Planning Application reference: 76795/APP/2021/3704

This Document has been prepared by Hunters to support the planning application for minor amendments proposed to the Yiewsley Housing and Library Scheme.

WHEELCHAIR USER UNIT

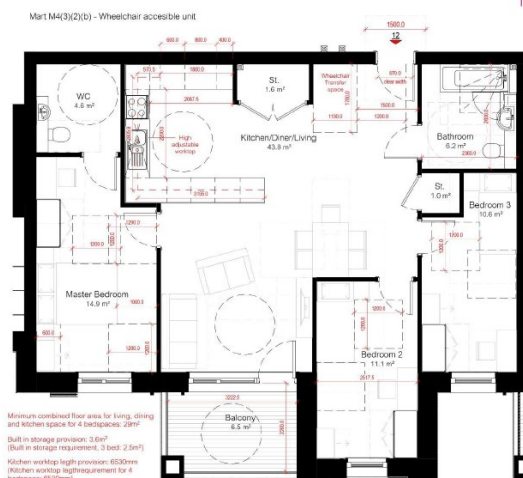
- Plans should be amended to demonstrate how the required M4(2) and M4(3) units satisfy the functional and spatial provisions for wheelchair adaptable and wheelchair accessible housing.

See previous response. Further information on a typical M4(3) unit with satisfactory functional and spatial provisions can be found on the Design & Access Statement.

2 number units are designed to be fully compliant with the optional requirement 2b of the Approved Document Part M to be wheelchair accessible.

3 number units will meet the optional requiring to be wheelchair adaptable.

All other units are designed M4(2).

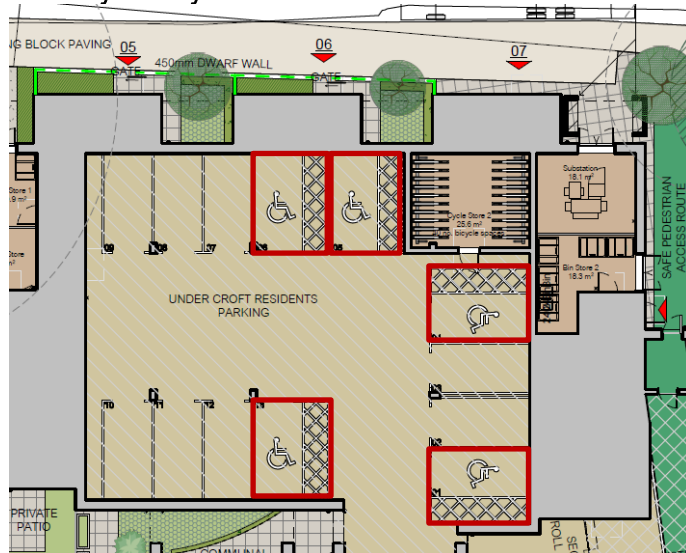
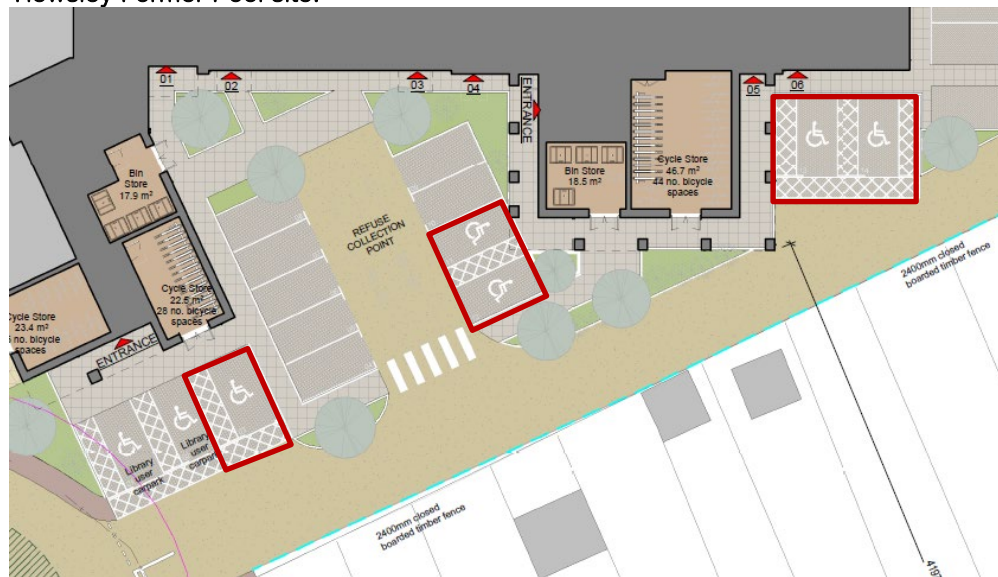
- An accessible parking space should be allocated to each of the required wheelchair accessible/adaptable dwellings, with a 1200 mm wide transfer area provided alongside. These units should be interspersed throughout the development, and each should be served by two lifts.

In both sites, designated parking spaces are provided for each wheelchair user unit. 1200mm transfer area provided in line with Part M of the Building Regulations.

Yiewsley Library site:

Yiewsley Former Pool site:
